I wish to submit my objection to the WestConnex M4-M5 Link proposals as contained in the EIS application # SSI 7485. The reasons for objecting are set out below.

Application Number: SSI 7485

Application Name: WestConnex M4-M5 Link

The EIS states in 6.5.8 Darley Road civil and tunnel site (C4) that:

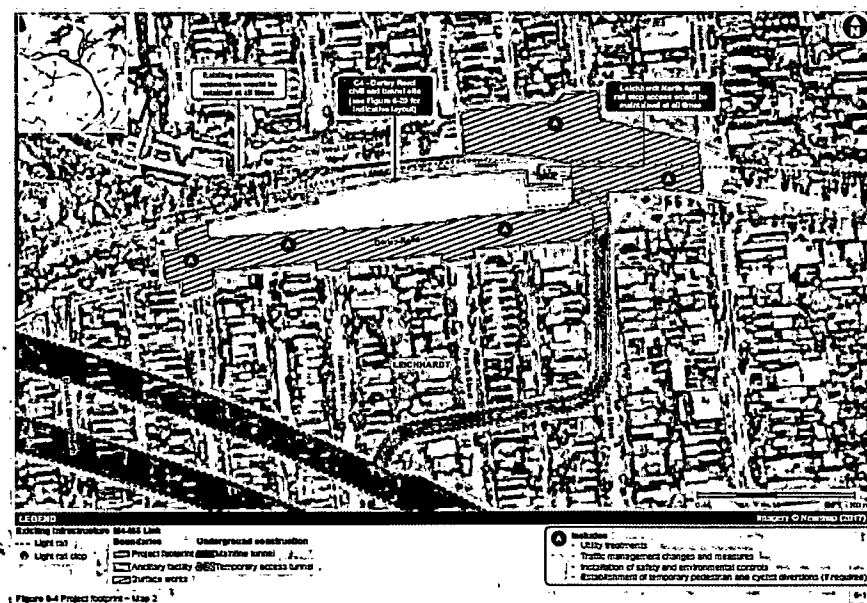
- I object** to the EIS because it fails to describe the temporary changes to Darley Road, Leichhardt to enable access to and from the ancillary facility that would likely be required in relation to the Darley Rd site and instead allows for the final plan to be decided by the contractor.

'Temporary changes to Darley Road to enable access to and from the ancillary facility would likely be required. These may include changes to line marking to provide a temporary turning lane for construction traffic and temporary diversions to the pedestrian path on the northern side of Darley Road. These would be confirmed during detailed design following the appointment of a design and construction contractor and in consideration of the safety and function of the road network, maintaining access to the Leichhardt North light rail stop and providing for continued pedestrian and cyclist movement.'

It is not clear how continued access, pedestrian and cyclist movement will be preserved and I am concerned that the impacts have not been correctly identified and assessed by the proponent.
